Proposal #25: 9140-12-81, WISC 2026427
Antigo - Langlade
Wolf River Bridge B-34-0061
STH 64
Langlade County

This is Addendum No. 01, which provides for the following:

**ADDENDUM NO. 01
PROJECT ID 9140-12-81
September 3, 2026**

Revised Sheet 31
September 3, 2026

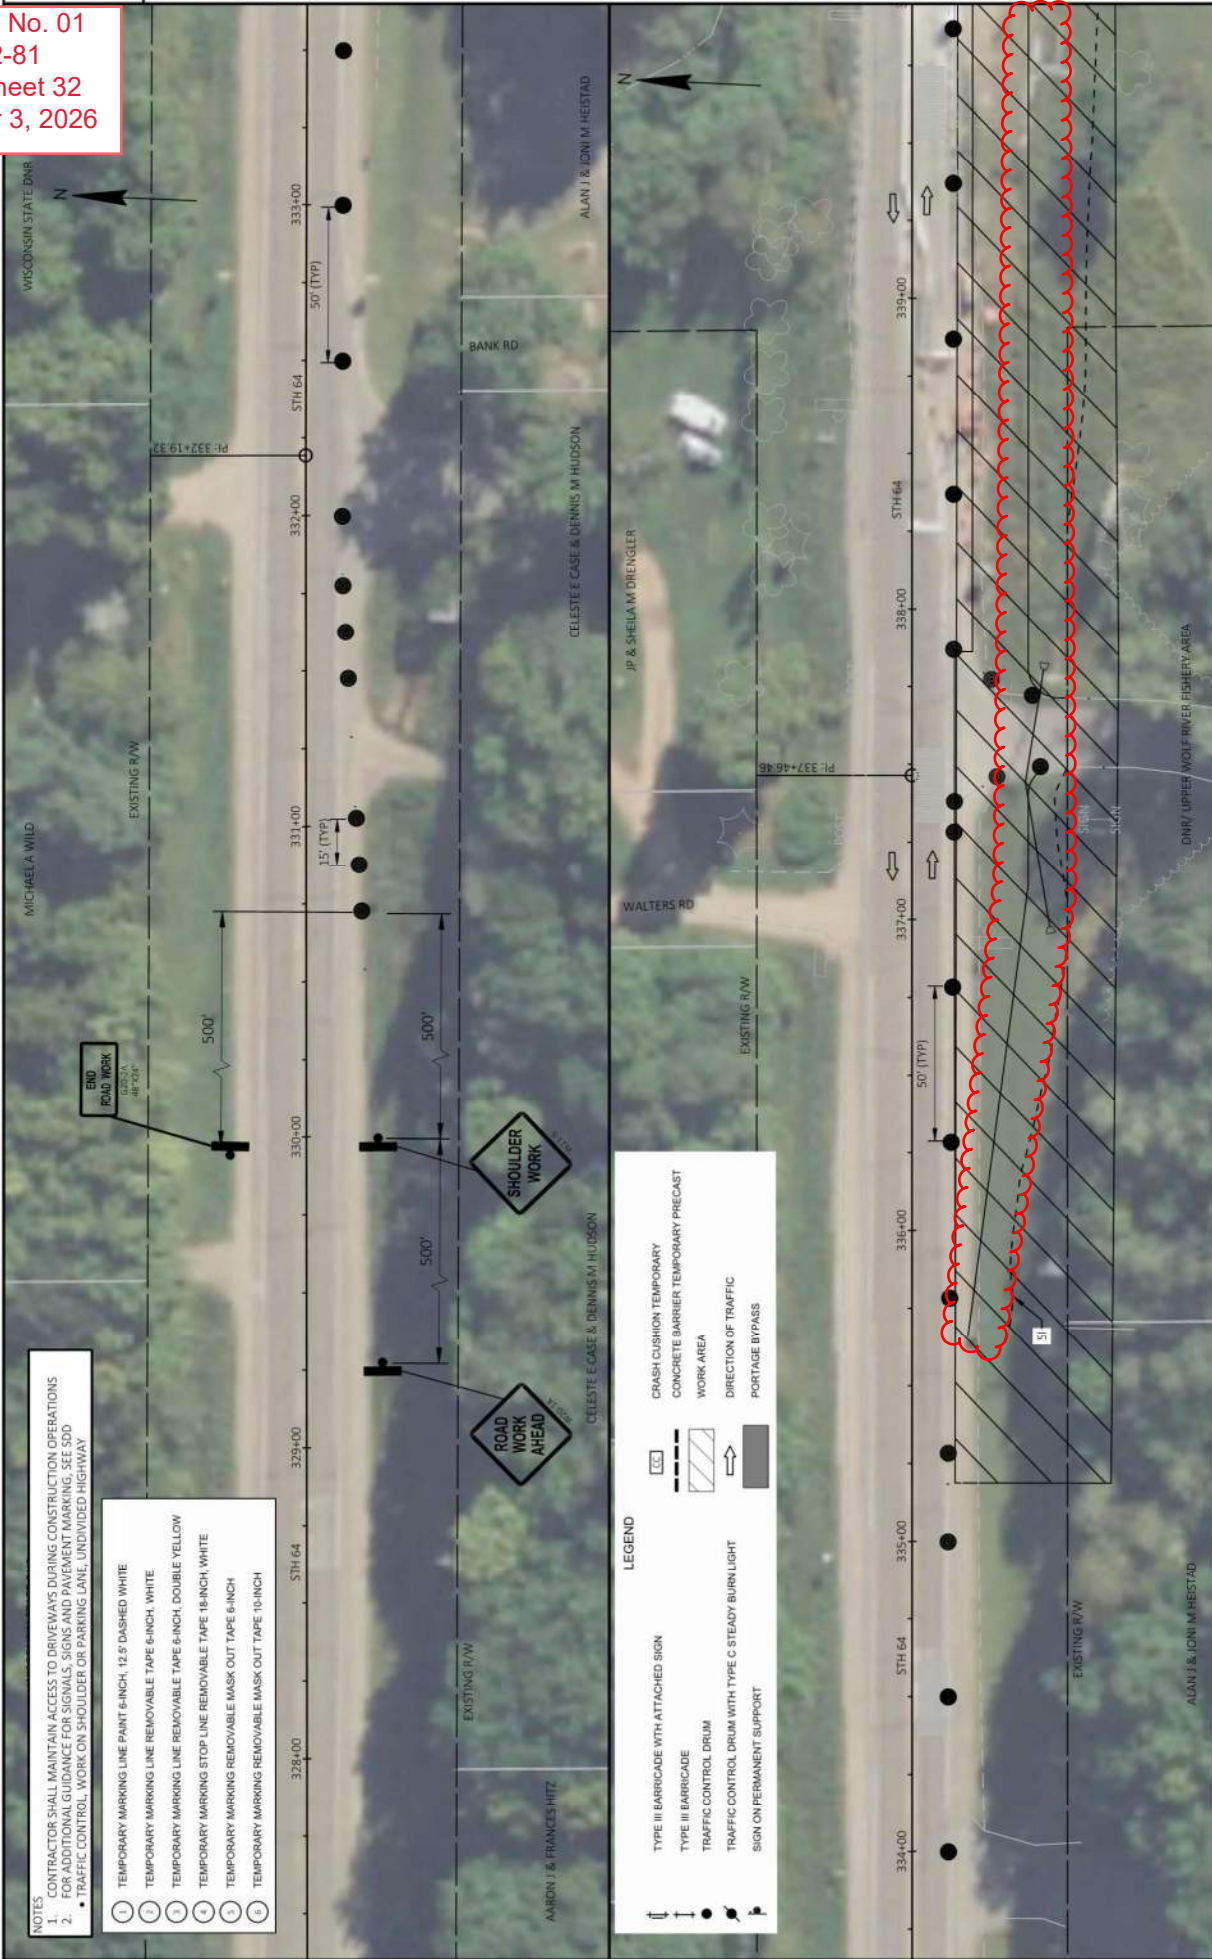
Revised Plan Sheets	
Plan Sheet	Plan Sheet Title (brief description of changes to sheet)
31	Traffic Control – Temporary Bypass Typical Section (Added Asphaltic Surface to shoulder)
32	Traffic Control – B-34-0061 – Stage 1A (Changes to temp bypass linework)
33	Traffic Control – B-34-0061 – Stage 1A (Changes to temp bypass linework)
34	Traffic Control – B-34-0061 – Stage 1B (Changes to temp bypass linework)
35	Traffic Control – B-34-0061 – Stage 1B (Changes to temp bypass linework)
36	Traffic Control – B-34-0061 – Stage 2 (Changes to temp bypass linework)
37	Traffic Control – B-34-0061 – Stage 2 (Changes to temp bypass linework)
38	Traffic Control – B-34-0061 – Stage 3A (Changes to temp bypass linework)
39	Traffic Control – B-34-0061 – Stage 3A (Changes to temp bypass linework)
40	Traffic Control – B-34-0061 – Stage 3B (Changes to temp bypass linework & work area)
41	Traffic Control – B-34-0061 – Stage 3B (Changes to temp bypass linework & work area)

Addendum No. 01
ID 9140-12-81
Revised Sheet 62
September 3, 2026

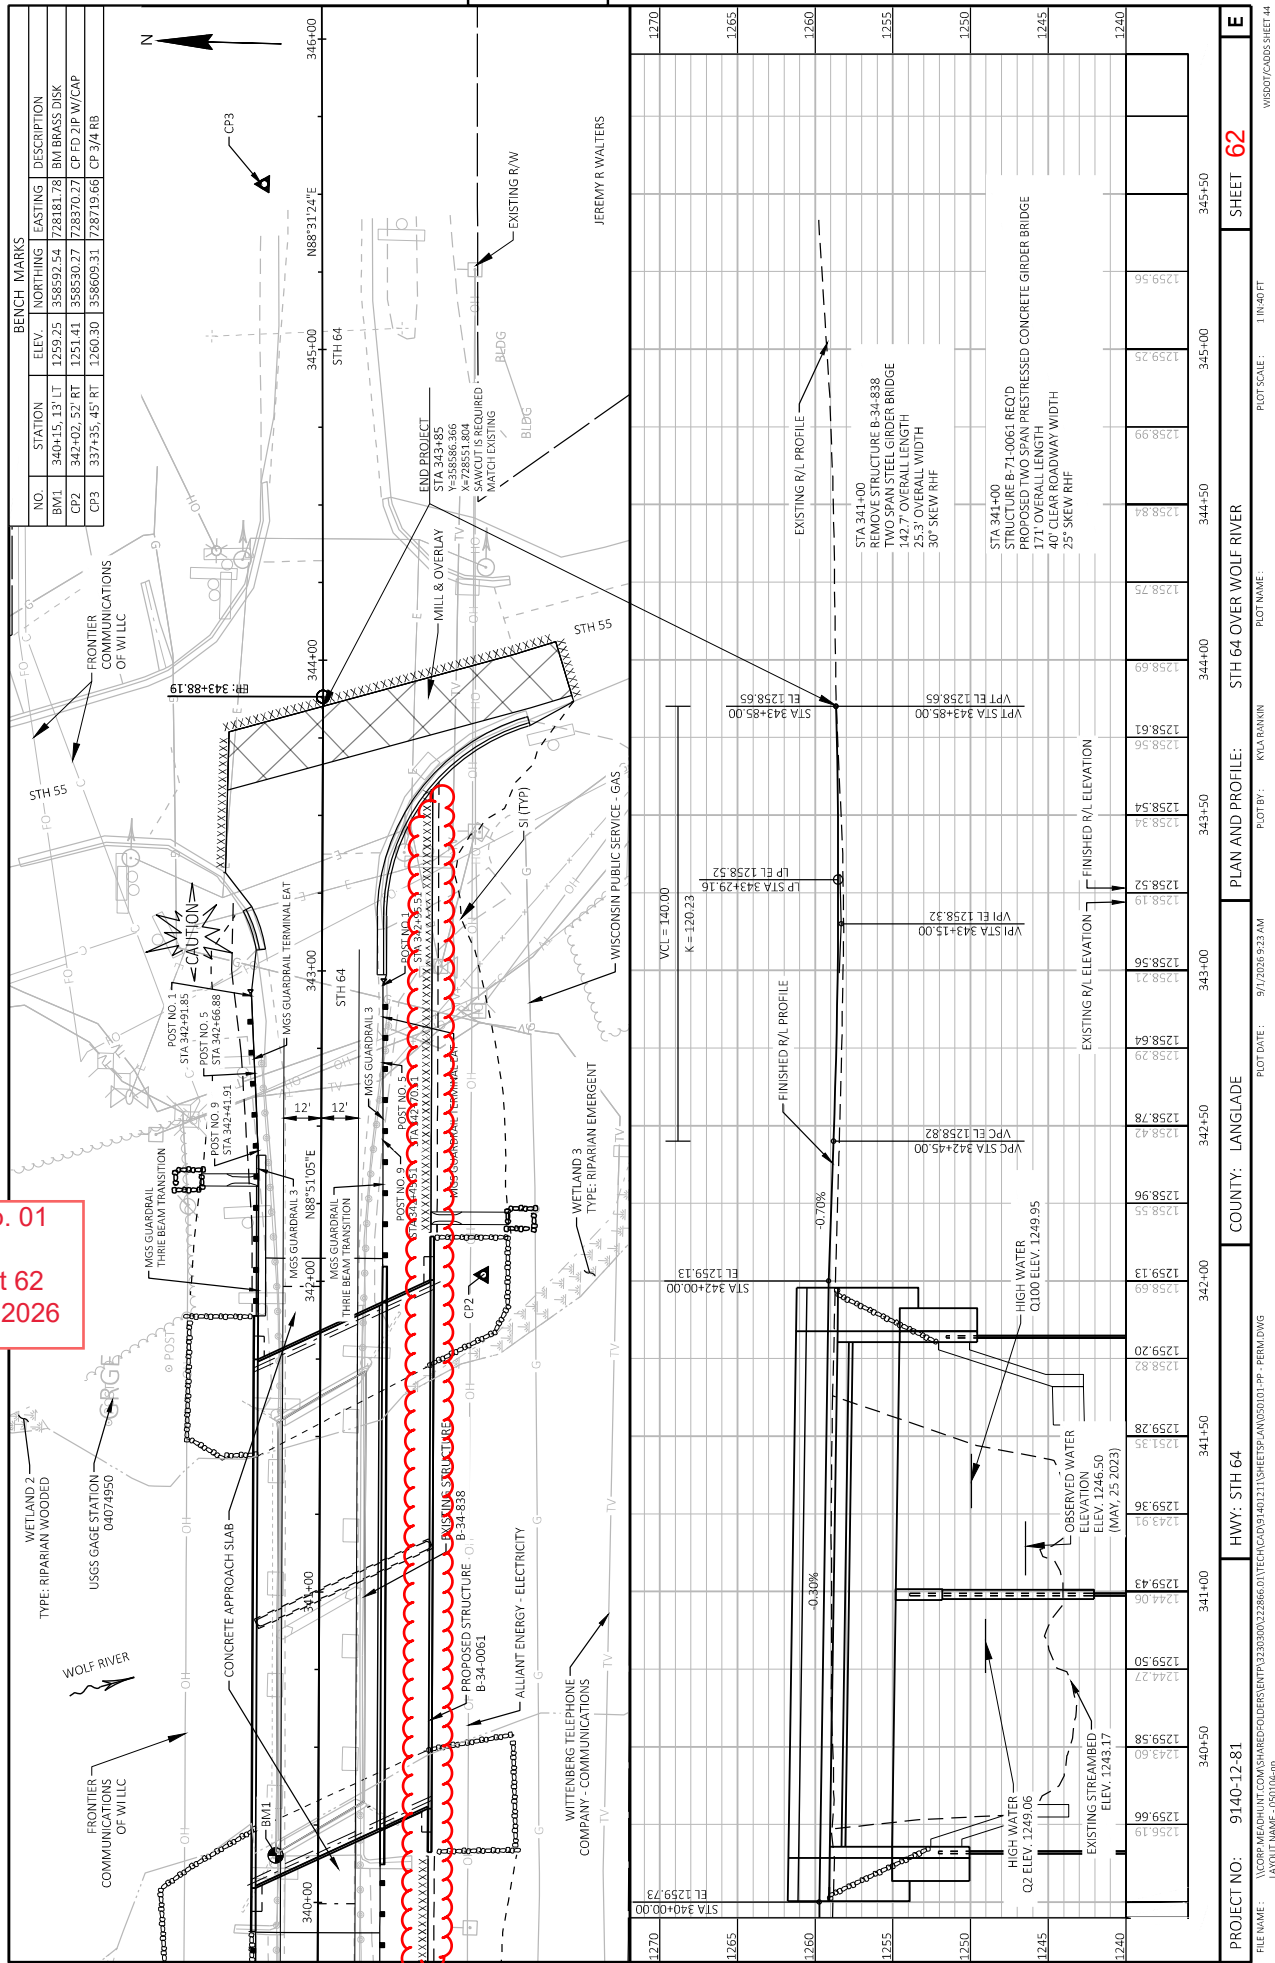
50	Miscellaneous Quantities (Quantity change for Removing Asphaltic Surface)
51	Miscellaneous Quantities (Quantity change for Asphaltic Surface)
55	Miscellaneous Quantities (Quantity change for DAYS and corresponding bid items)
57	Miscellaneous Quantities (Quantity change for Sawing Asphalt)
59	Plan and Profile: Temporary Bypass Over Wolf River (Changes to temp bypass linework)
60	Plan and Profile: Temporary Bypass Over Wolf River (Changes to temp bypass linework)
61	Plan and Profile: STH 64 Over Wolf River (Changes to temp bypass linework)
62	Plan and Profile: STH 64 Over Wolf River (Changes to temp bypass linework)
